Technical Service Bulletin

10 Oil is lost from the filler cap

10 22 24 2059446/5 August 23, 2022. Supersedes Technical Service Bulletin Group 10 number 21-21 dated March 8, 2021, for reasons listed below.

Figure 1. Breather line for the Turbocharged V6.

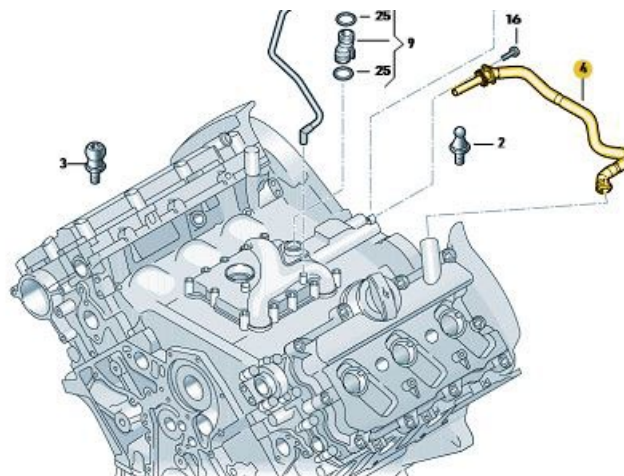
A faulty membrane in the breather line can result in excess pressure in the crankcase and therefore some oil is lost through the filler cap.

Replace the breather line (different variants available, only order by VIN) by following the Elsa repair manual (Figures 1 and 2).

A breather line with an improved membrane has been implemented in production.
